# Product Change Notification

## 106791 - 01

**Change Notification #:** 106791 - 01  
**Change Title:** MPFAN0001 Fan Tray Spare, PCN 106791-01, Product Design, Update Spare Part and Manufacturing Site,  
**Reason for Revision:** Updating TA# of Spare Part Assembly  
**Date of Publication:** November 8, 2006

**Table 1. Changes from PCN105089**

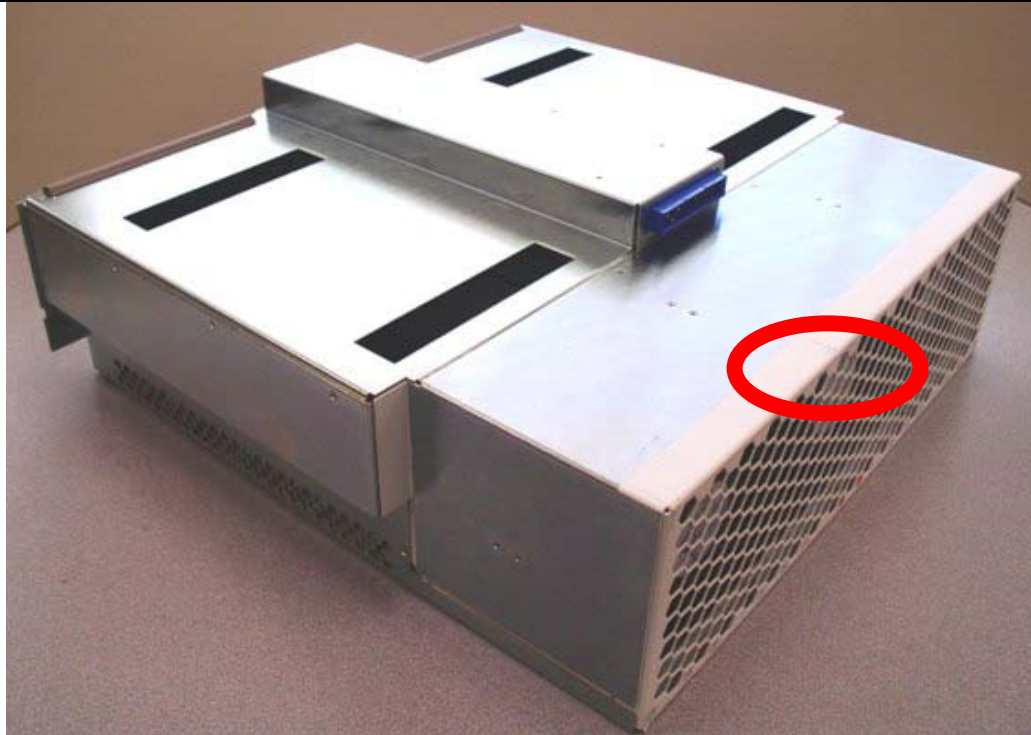
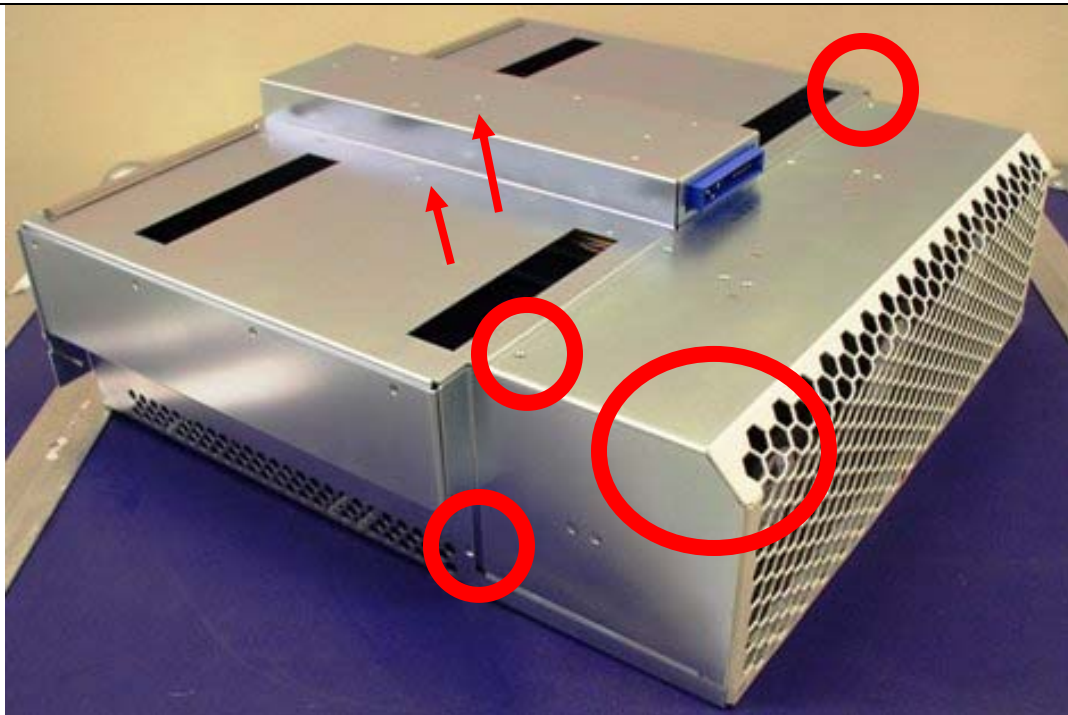
**Current Fan Tray – Note scratches on paint**

**New Fan Tray – Note dimples and chamfer. Added 2 screws on top exhaust bracket. Removed 1 screw (on each side). Note: Side screw is shown in picture but should not be there.**

WAS	IS	DESCRIPTION	REASON FOR CHANGE
C14224-014	<b>C94944-004</b>	Fan Tray Assembly	All Sheet Metal changed to improve cosmetic quality  See below for additional changes to Fan Tray:
C51284-004	C51284-006	Fan Tray Front Overlay	Thicker Adhesive; reduce outside dimension
C51286-002	C51286-003	Fan Tray Rear Overlay	Thicker Adhesive; add radii to corners, reduce width
A95800-403	A95800-502	Fan Tray PBA	Enhancing manufacturability and fit of boards to meet with redesigned chassis sheet metal; reduced hole registration; new LED; adding screws for Positronic connectors  Firmware Update to V1.9
C14346-006	C93426-004	Fan Tray Bottom Panel	Modified to meet new exhaust panel  Improved manufacturability  Remove label targets
C14347-006	C93427-004	Fan Tray Top Panel	Added dimples to resolve black marks  Changed label targets
C34319-003	C93440-004	Fan Tray Rear Exhaust Panel	Add chamfer at rear of assembly to resolve black marks  Improved manufacturability

C14338-006	<b>C93425-004</b> <b>C93425-003 (alt)</b>	Fan Mounting Bracket	Add guide pins holes to improve assembly  <b>Replaced PEM nuts with extruded punched tapped holes</b>  <b>(alt) Alternate part may be used – part has PEM nuts</b>
<b>C13937-005</b>	<b>C13937-007</b>	<b>Fan Tray Fans</b>	<b>Updated fan includes “twisted” wiring of ground/tachometer</b>  <b>All wires bundled heat shrink from each fan</b>  <b>Updating fan model to reduce tachometer noise</b>  Fan orientation will be different

**Table 2. Changes from PCN106303**

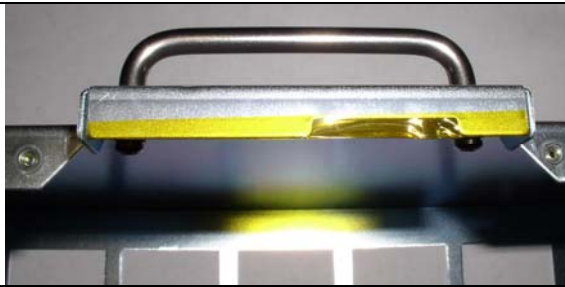
**Fan tray insulator**

Adjust length of Insulator between fan tray board and top sheet metal to better fit.

Create another insulator to cover area currently being covered by Kapton tape on the front inside of the fan tray, as shown below.

Fan Tray assembly # will change from C94944-004 to C94944-005.

Old – Kapton Tape

New – Kapton insulator

**Table 3. Changes from PCN106322**

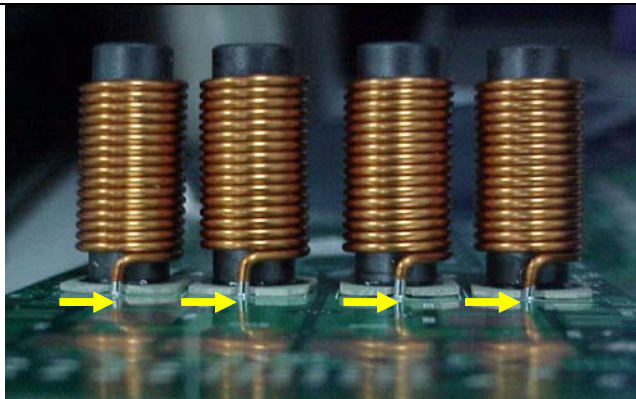
Fan Tray Board Inductor change and base added to improve manufacturing yield, as shown below.

Fan Tray assembly # will change from C94944-005 to C94944-006, Fan PBA from A95800-502 to A95800-503.
